SUBJECT: FY18 Periodic Inspection, Flood Risk Management Project, Reno Beach-Howard Farms, Lucas County, Ohio (08/22/18)

Lake Erie – Reno Beach

FY 2018 PERIODIC INSPECTION REPORT

INSPECTED 22 AUGUST 2018

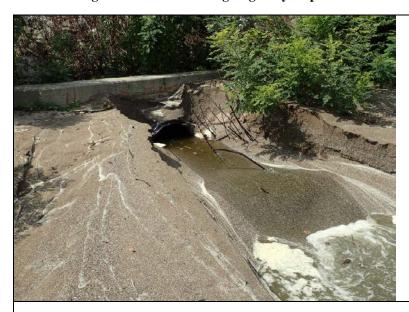
Inspect ID: OH29_2018_p_0107 **Title:** USACE_CELRB_OH29_2018_p_0107_2.jpg **Rated Item:** 11. Culverts/ Discharge Pipes (This item includes both concrete and corrugated metal pipes.) **Caption:** Rating: Unacceptable; Remarks: Drainage ditch pump station discharge at intersection of Dyke Road and Corduroy penetrates through the levee system and has not been videotape inspected within last 5-years.; Action: Videotape inspect condition of discharge pipe and submit, with engineering evaluation and ratings, to USACE.

Inspect ID: OH29_2018_p_0107 Title: USACE_CELRB_OH29_2018_p_0107_3.jpg Rated Item: 11. Culverts/ Discharge Pipes (This item includes both concrete and corrugated metal pipes.) Caption: Rating: Unacceptable; Remarks: Drainage ditch pump station discharge at intersection of Dyke Road and Corduroy penetrates through the levee system and has not been videotape inspected within last 5-years.; Action: Videotape inspect condition of discharge pipe and submit, with engineering evaluation and ratings, to USACE.

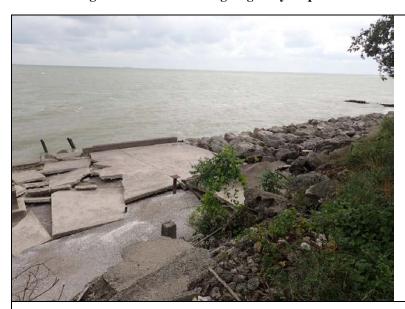
| 40 | M | Deteriorated concrete revetment on waterside of levee, shown on As-Built Sheet 9 of 28 on Drawing Number 86-RBP-1/9, is incorporated into the project. The failing concrete is starting to expose the toe of the waterside slope. | | 40_1.jpg 40_2.jpg 40_3.jpg | Levee Embankments | Revetments other than Riprap | NA | 50+60 | NA |

Inspect ID: OH29_2018_p_0040 Title: USACE_CELRB_OH29_2018_p_0040_1.jpg Rated Item: 13. Revetments other than Riprap Caption: Rating: Minimally Acceptable; Remarks: Deteriorated concrete revetment on waterside of levee, shown on As-Built Sheet 9 of 28 on Drawing Number 86-RBP-1/9, is incorporated into the project. The failing concrete is starting to expose the toe of the waterside slope.; Action: Repair concrete revetment or replace with suitable material to protect levee.

Inspect ID: OH29_2018_p_0040 **Title:** USACE_CELRB_OH29_2018_p_0040_2.jpg **Rated Item:** 13. Revetments other than Riprap **Caption:** Rating: Minimally Acceptable; Remarks: Deteriorated concrete revetment on waterside of levee, shown on As-Built Sheet 9 of 28 on Drawing Number 86-RBP-1/9, is incorporated into the project. The failing concrete is starting to expose the toe of the waterside slope.; Action: Repair concrete revetment or replace with suitable material to protect levee.

Inspect ID: OH29_2018_p_0040 Title: USACE_CELRB_OH29_2018_p_0040_3.jpg Rated Item: 13. Revetments other than Riprap Caption: Rating: Minimally Acceptable; Remarks: Deteriorated concrete revetment on waterside of levee, shown on As-Built Sheet 9 of 28 on Drawing Number 86-RBP-1/9, is incorporated into the project. The failing concrete is starting to expose the toe of the waterside slope.; Action: Repair concrete revetment or replace with suitable material to protect levee.

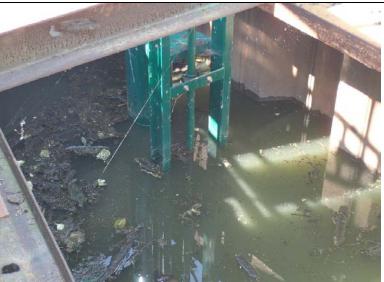
Inspect ID: OH29_2018_p_0042 Title: USACE_CELRB_OH29_2018_p_0042_1.jpg Rated Item: 1. Pump Stations Operating, Maintenance, Training, & Inspection Records Caption: Rating: Acceptable; Remarks: Project Pump Station at east end of Dyke Road. Records of operation are tracked hourly. 150-200 million gallons per year. Pump Station exercised during inspection.; Action: NA
